Lower Thames Crossing

10.4 Change Application (August 2023)

Planning Inspectorate Scheme Ref: TR010032
Examination Document Ref: TR010032/EXAM/10.4

Plate 4.1 Reduction of nitrogen deposition compensation area and Order Limits at Blue Bell Hill and Burham

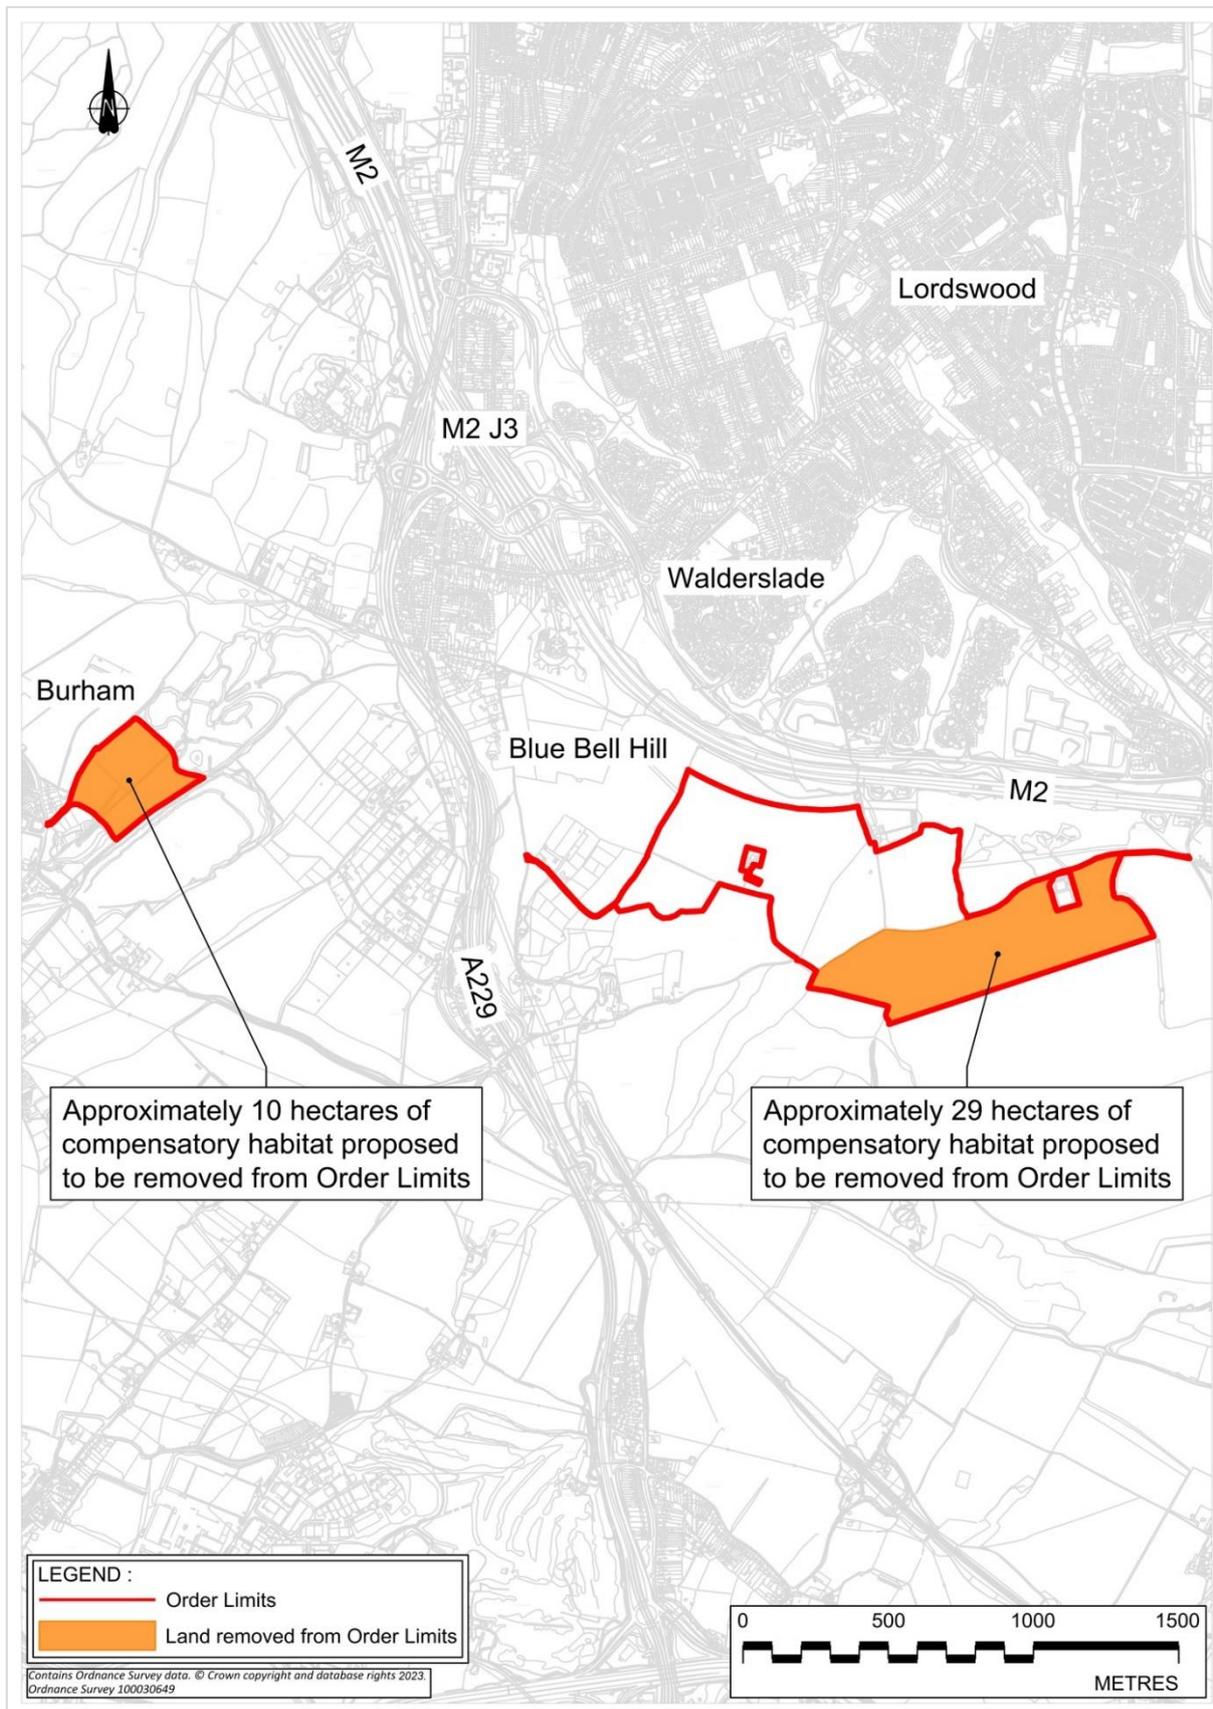
- 4.1.4 In response, the Applicant has identified an opportunity to make modifications to the Burham (Works No. E2) and Blue Bell Hill (Works No. E1) nitrogen deposition compensation sites to reduce the amount of land to be taken while still providing sufficient compensation.

- 4.2.1 The Applicant has reviewed the new information provided by the landowner and has revisited the process set out in ES Appendix 5.6: Project Air Quality Action Plan [**Application Document [APP-350](#)**].
- 4.2.2 The Applicant has concluded that sufficient compensation can be provided within Cossington Field alone and that Reservoir Field and the Burham site would not now be required to achieve the ecological objectives of additional connectivity and comparable area of compensation to affected habitat – while reducing impact on the farm business and agricultural land as well as reducing cultural heritage effects.
- 4.2.3 The Applicant is in discussion with the landowner and is hopeful that an agreement can be reached to purchase the remaining 43ha at Cossington Field for the nitrogen deposition compensation site, thereby avoiding the need for compulsory acquisition.

Plate 5.1 Limit of deviation (LOD) for the northern tunnel entrance headwall at DCO application

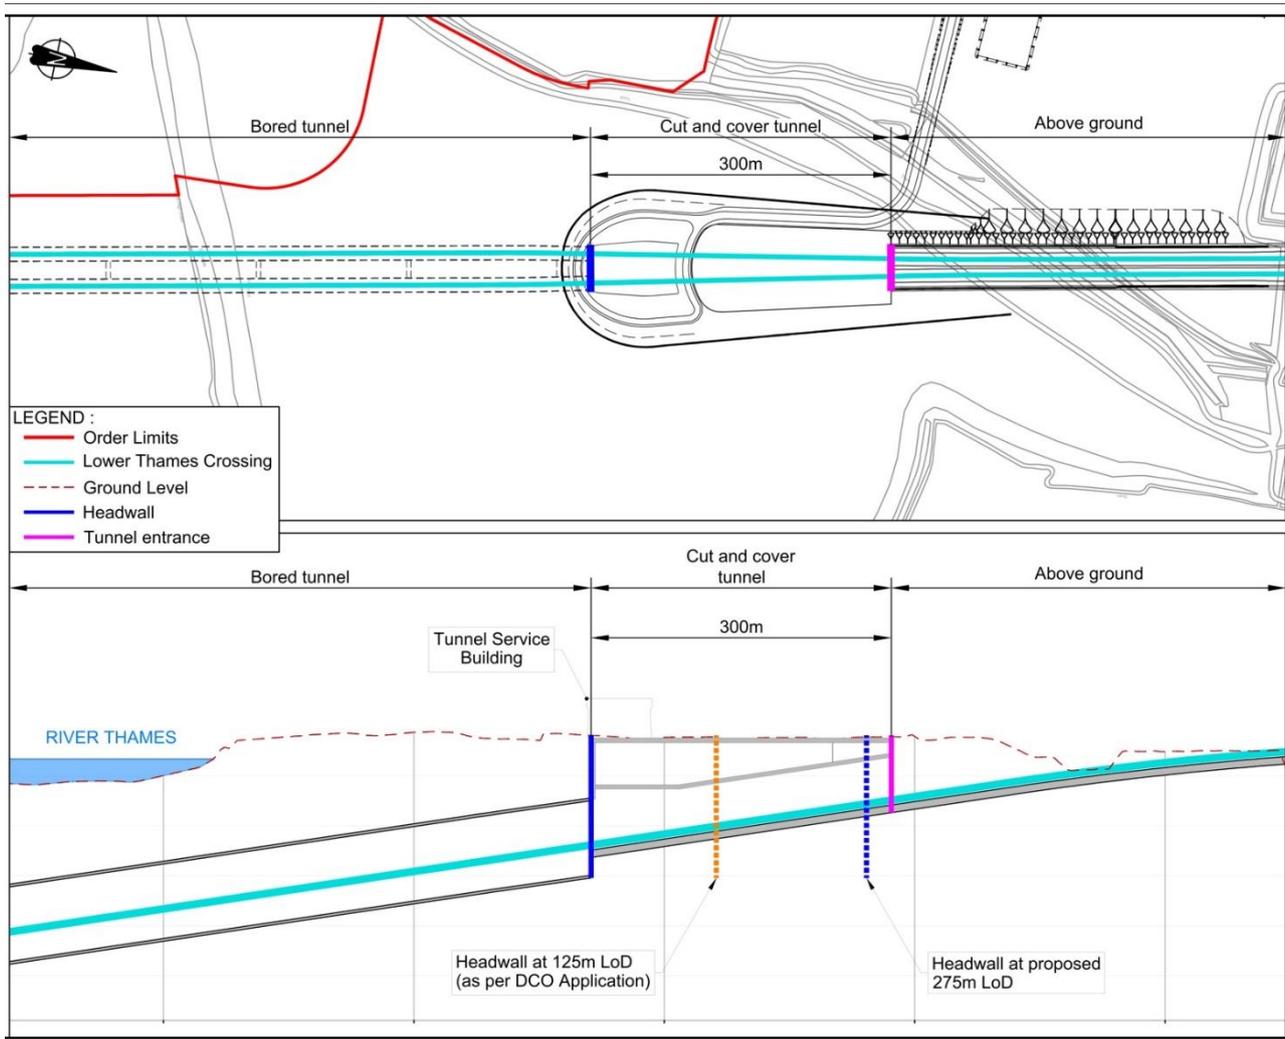
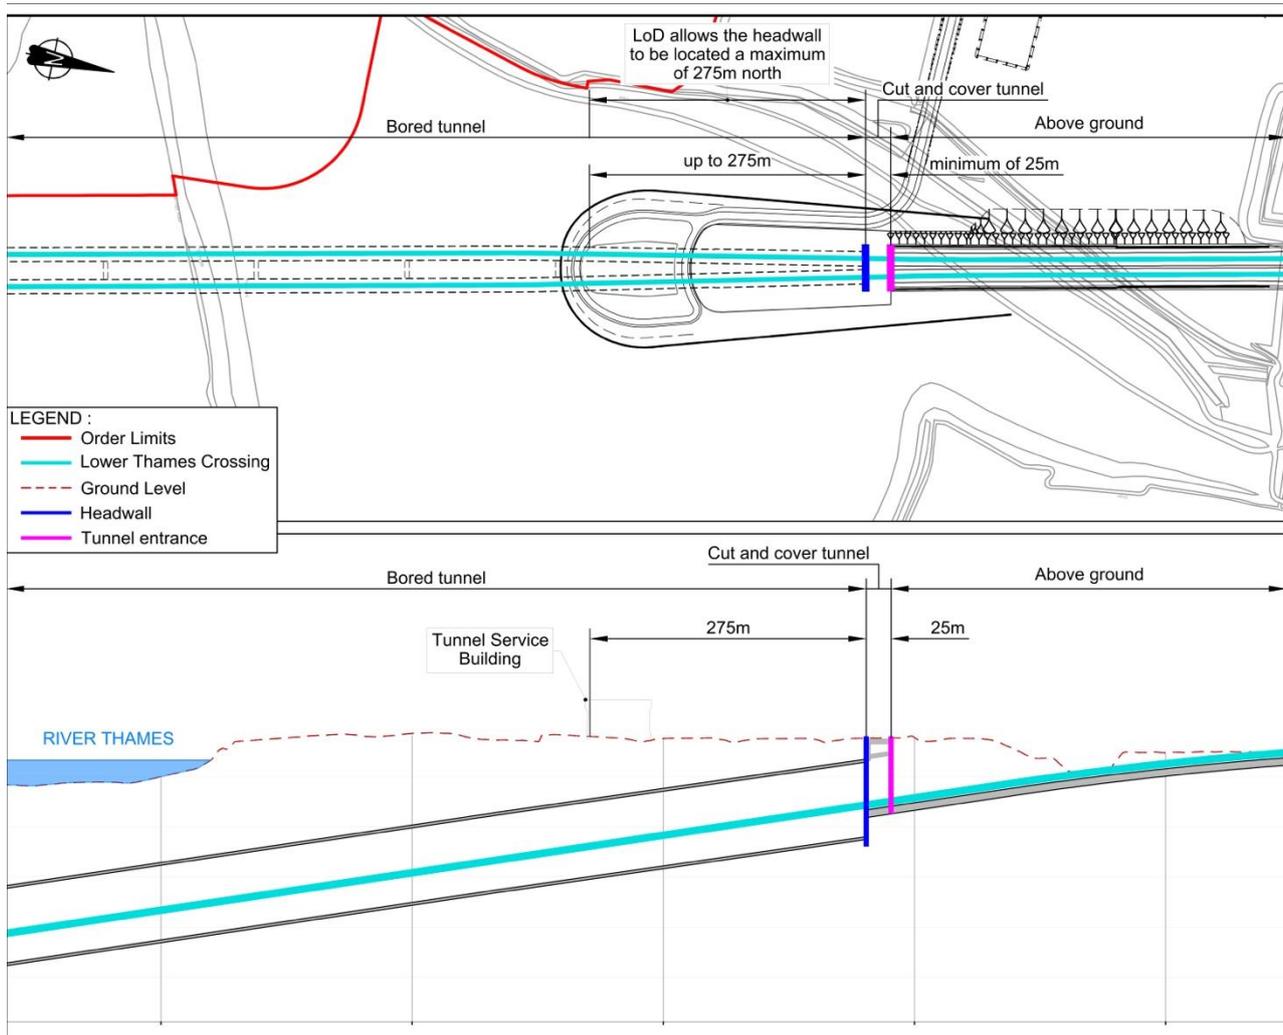
- 5.2.1 This change can be made by increasing the limits of deviation, described as the 'Limit of deviation on bored tunnel headwall' on Sheet 2 of the Tunnel Limits of Deviation Plans [**Application Document [APP-046](#)**] from 125m North on alignment to 275m North on alignment.

Plate 6.2 Revised utility proposals at East Tilbury resulting from proposed change

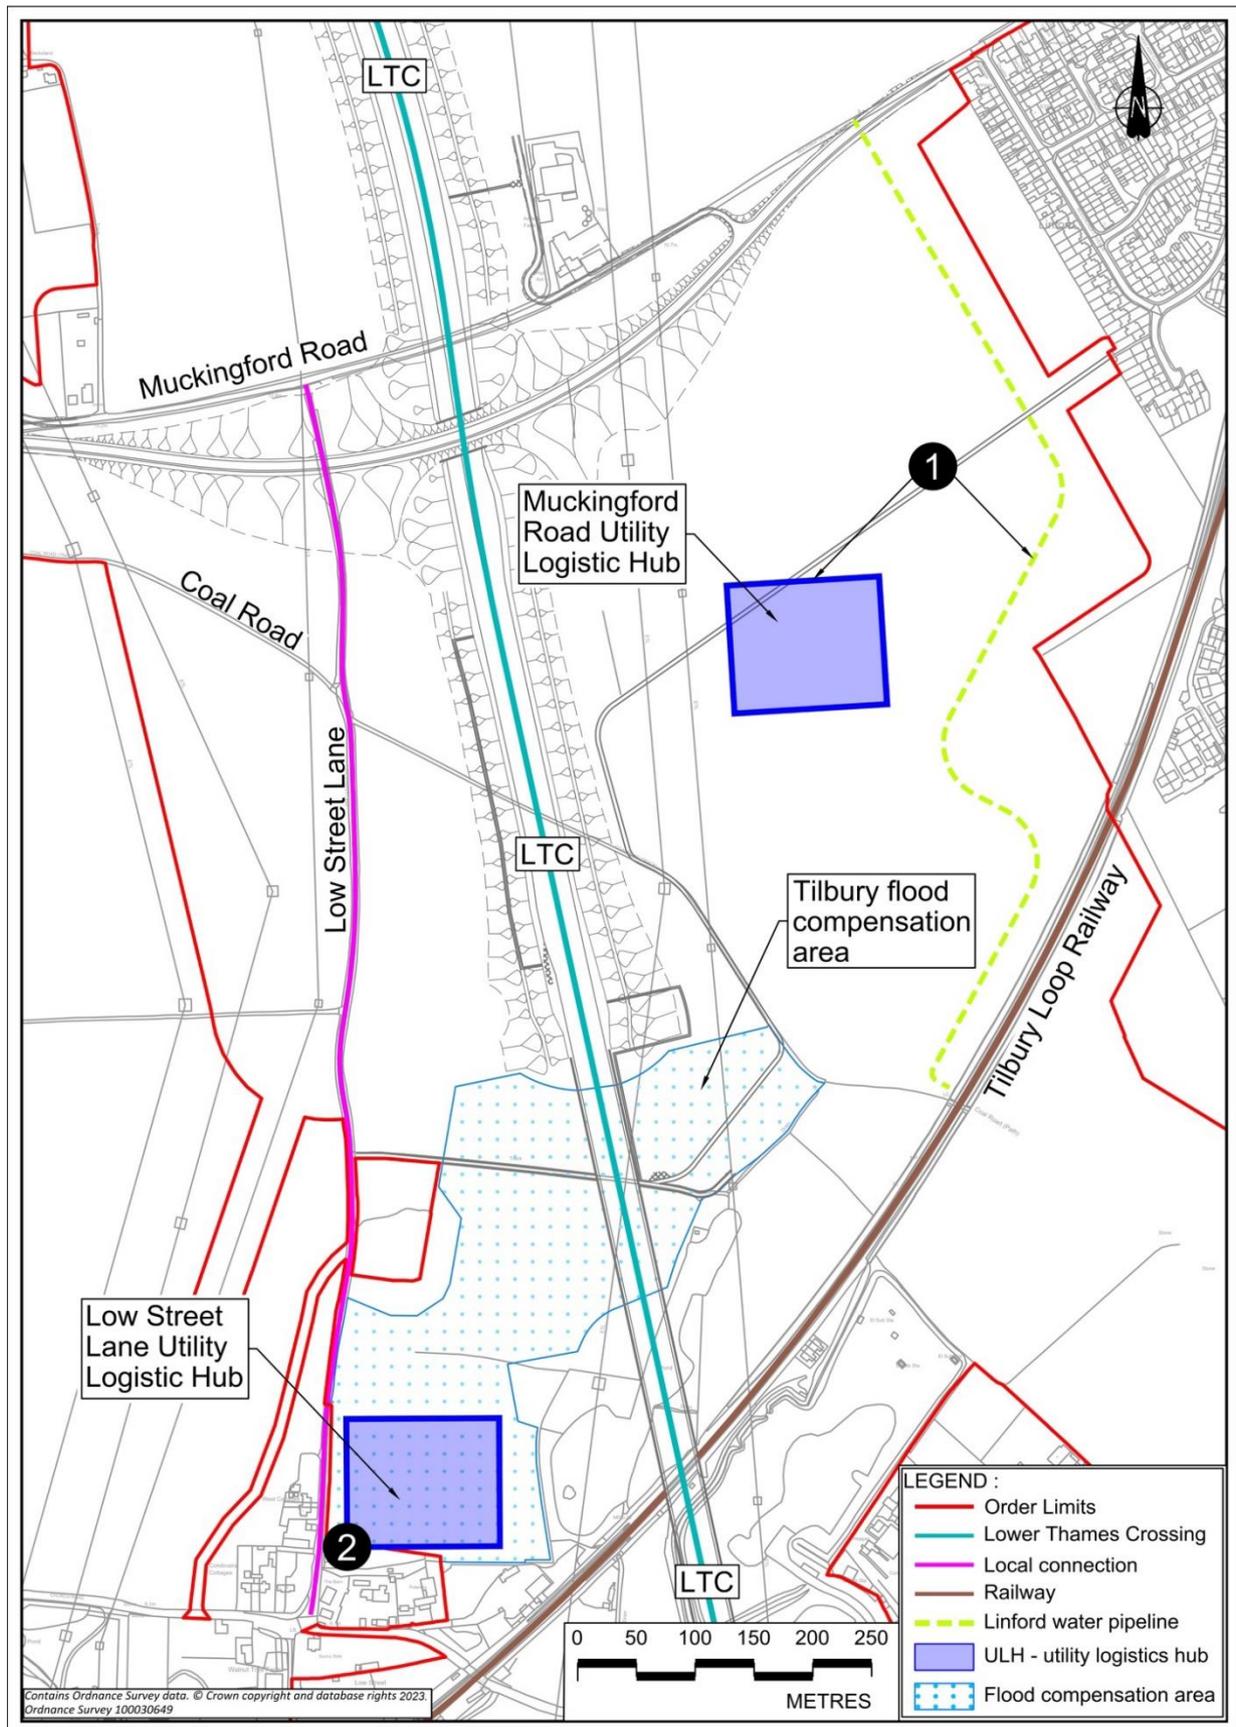
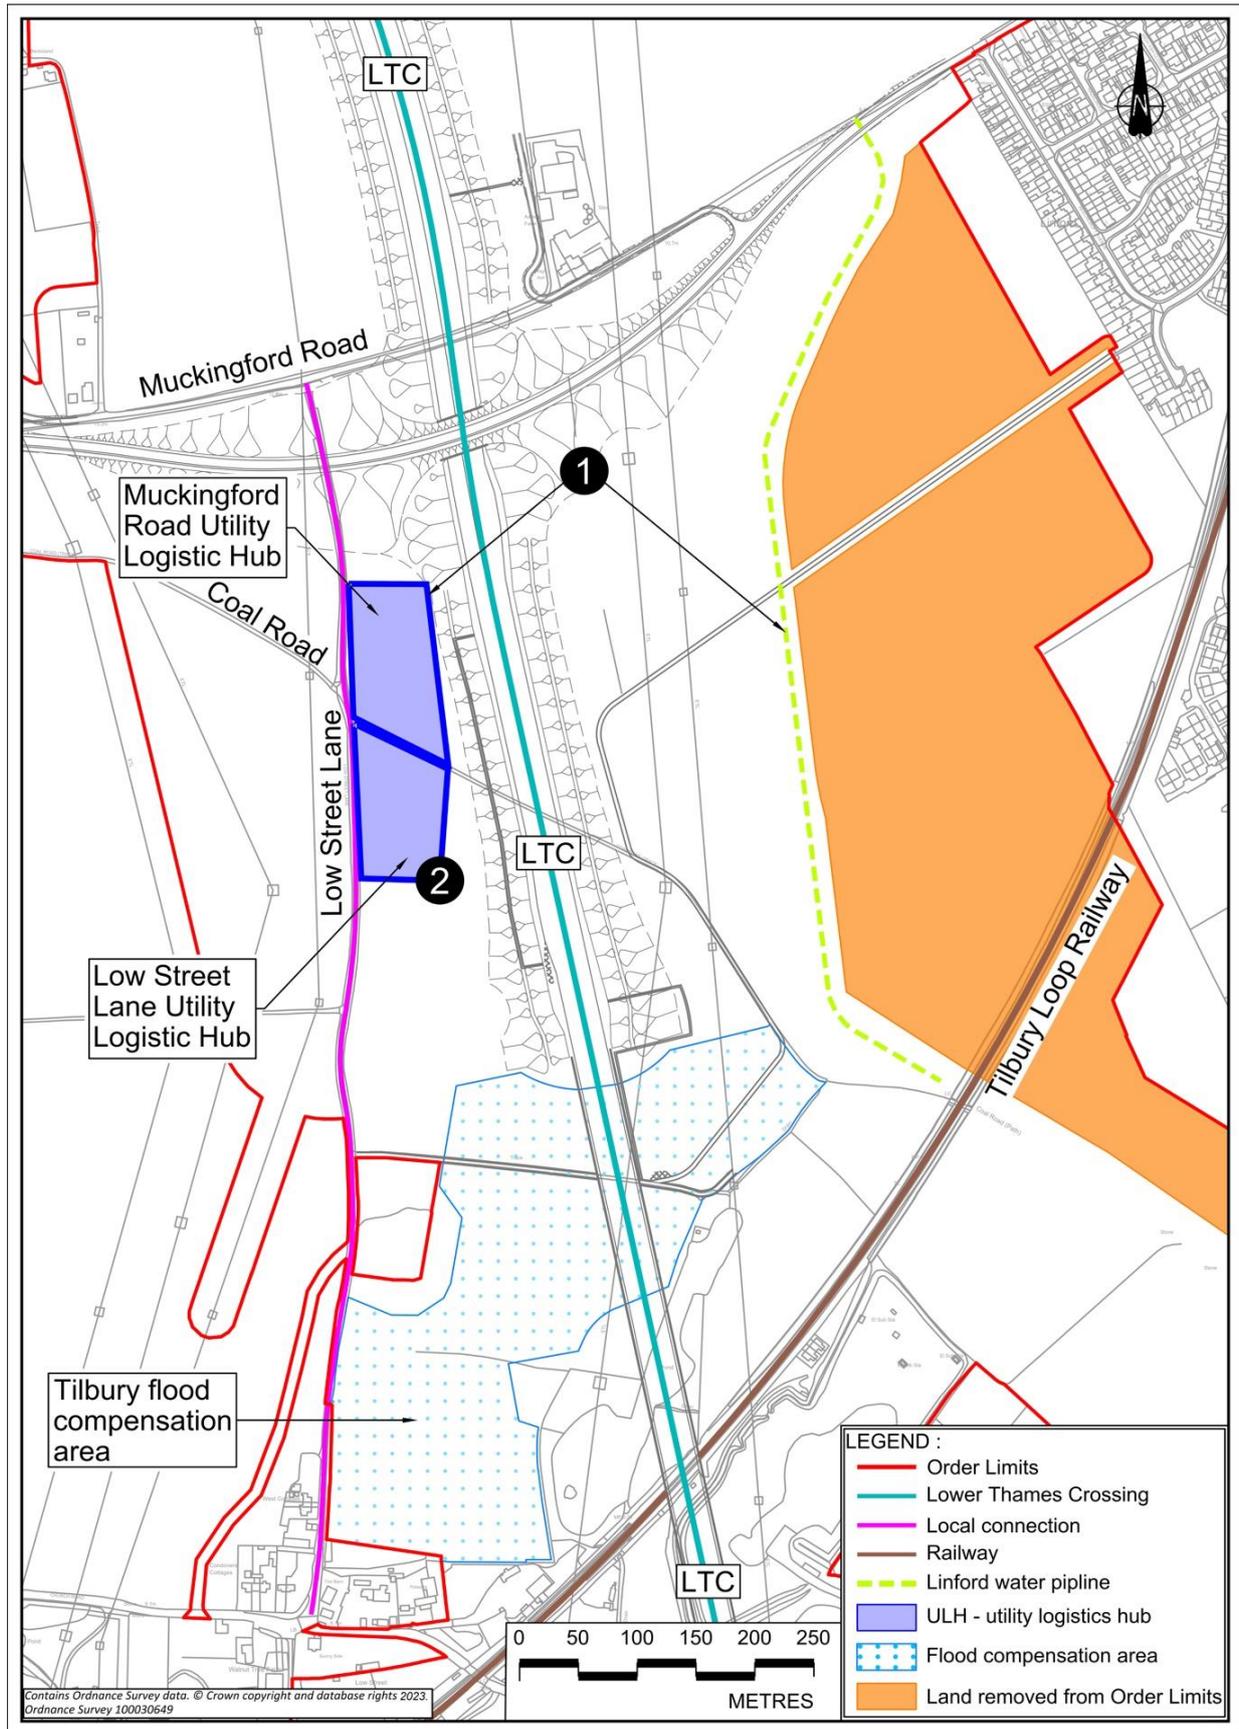
- 6.2.3 It is proposed to consolidate the Muckingford Road and Low Street Lane Utility Logistic Hubs (ULH 12) at a single location on both sides of Coal Road, Tilbury adjacent to Low Street, Tilbury (within the existing Order Limits). The Muckingford Road ULH will be moved approximately 350m west, and the Low Street Lane ULH approximately 550m north, of the locations shown in the DCO application.
- 6.2.4 There is no change to the proposed construction traffic access for the Utility Logistic Hubs which will remain off Muckingford Road using the construction access road.

- 6.2.6 The proposed relocation of Work No. MUT6 requires a change to the land designation of a portion of Plot 23-96 from temporary use (shaded green in the

land plans [**Application Document APP-008** and Additional Submission **AS-010**] to temporary use and permanent acquisition of rights (shaded blue in the land plans).
